**H2Oaks Desalination Facility, Well  
Field Collection Pipeline Project  
SAWS Job No. 19-8610  
SAWS Solicitation No. CO-00320**

**ADDENDUM NO. 3  
April 9, 2020**

DESIGN BY:	SDK
DRAWN BY:	KJ
CHECKED BY:	RM
APPROVED BY:	RM
JOB NO:	6542-0233
DATE:	2020-02-19
SHEET:	C-110

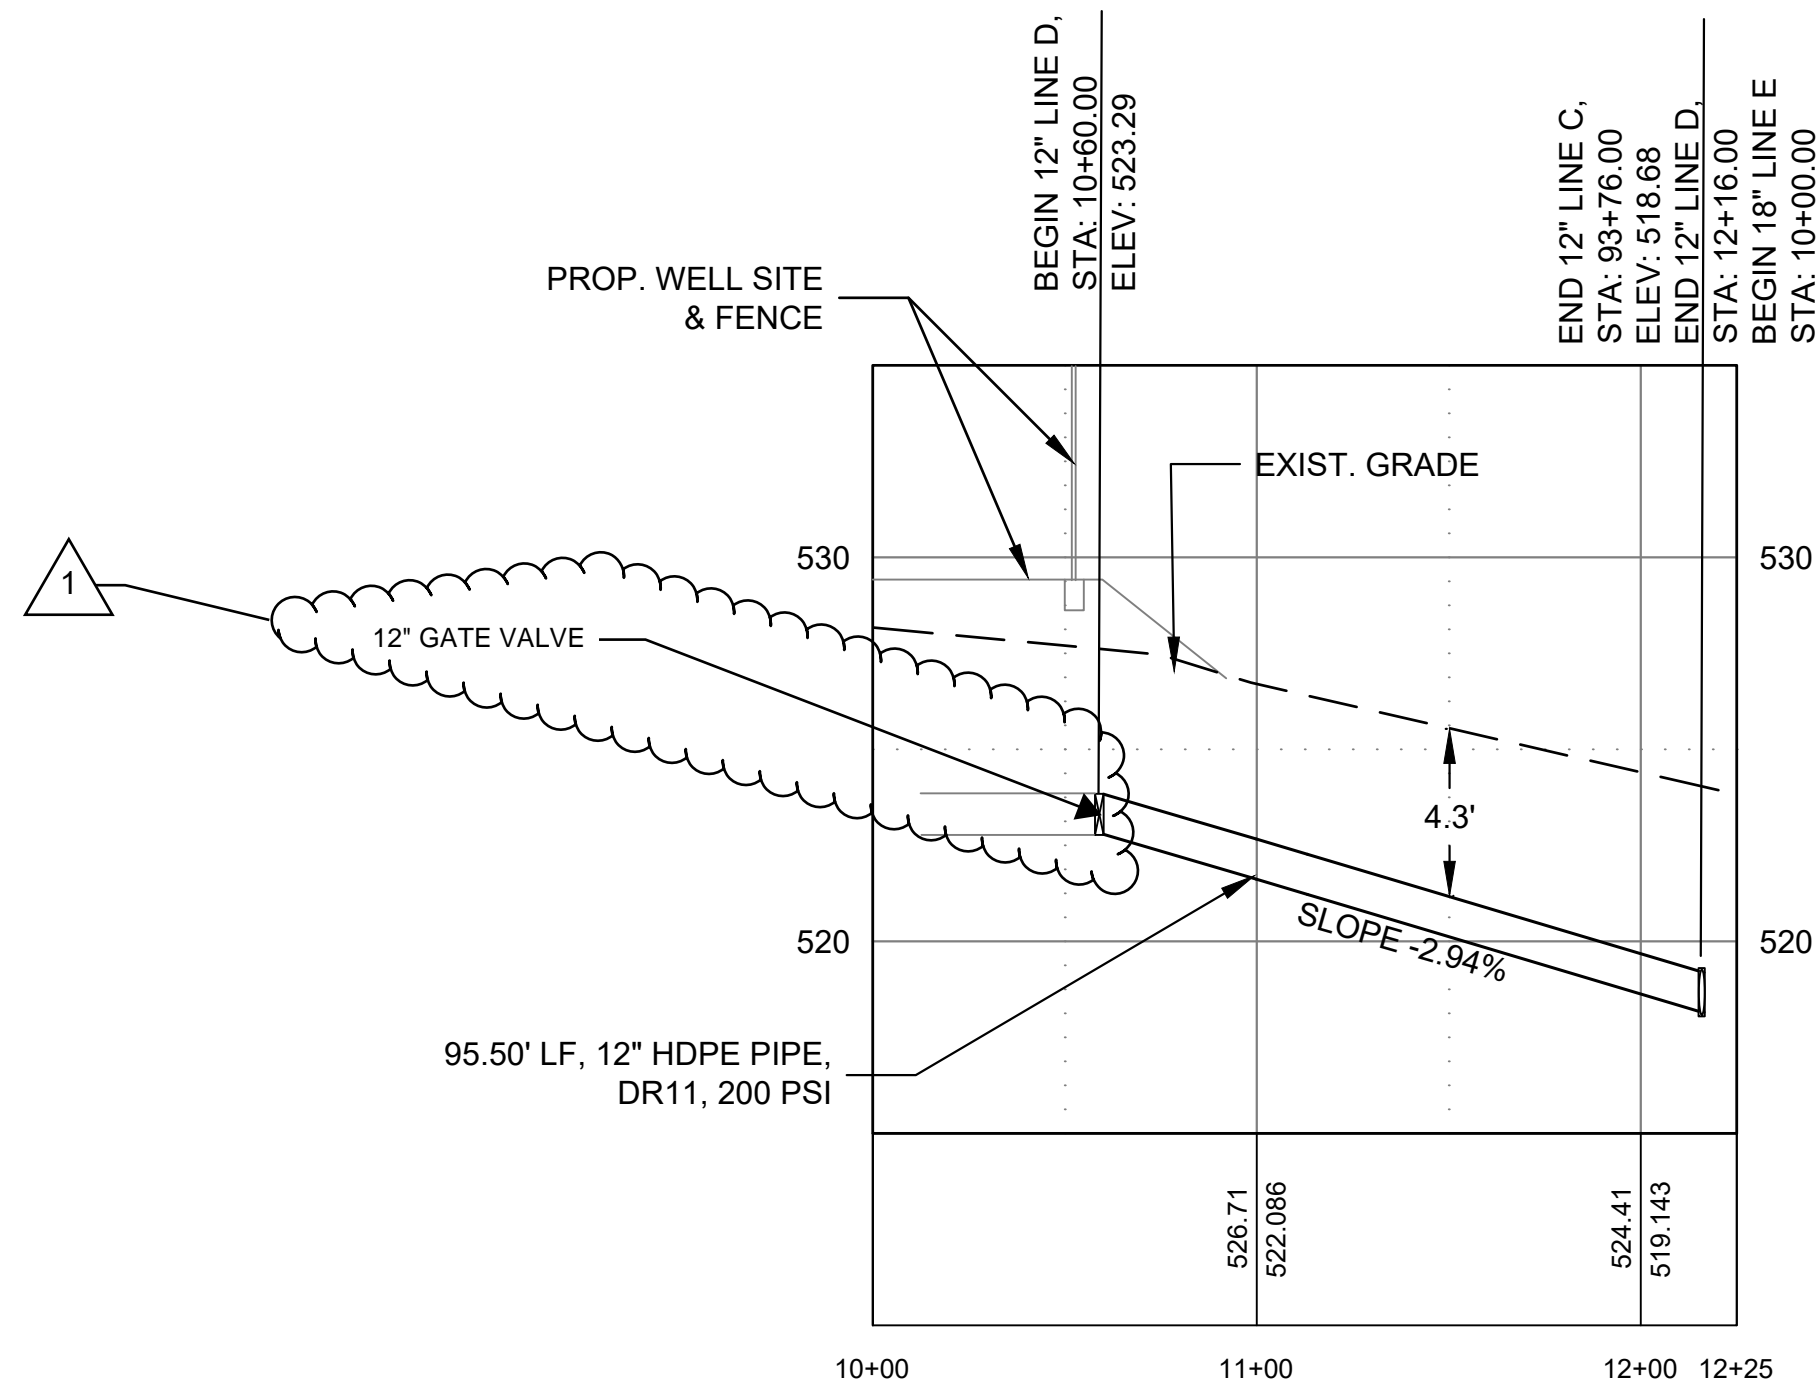
**3. Question 11: Sheet C110 Summary of quantities calls for 1 EA – 12 inch gate valve but the item is not shown in the plan or profile views. Clarification may save an argument later for a change order.**

*Revised Response: **The profile view shows the symbol for a 12-inch gate valve and Contractor shall account for this valve in his/her bid. The valve shall be placed at station 10+60.00 as shown on the profile view.***
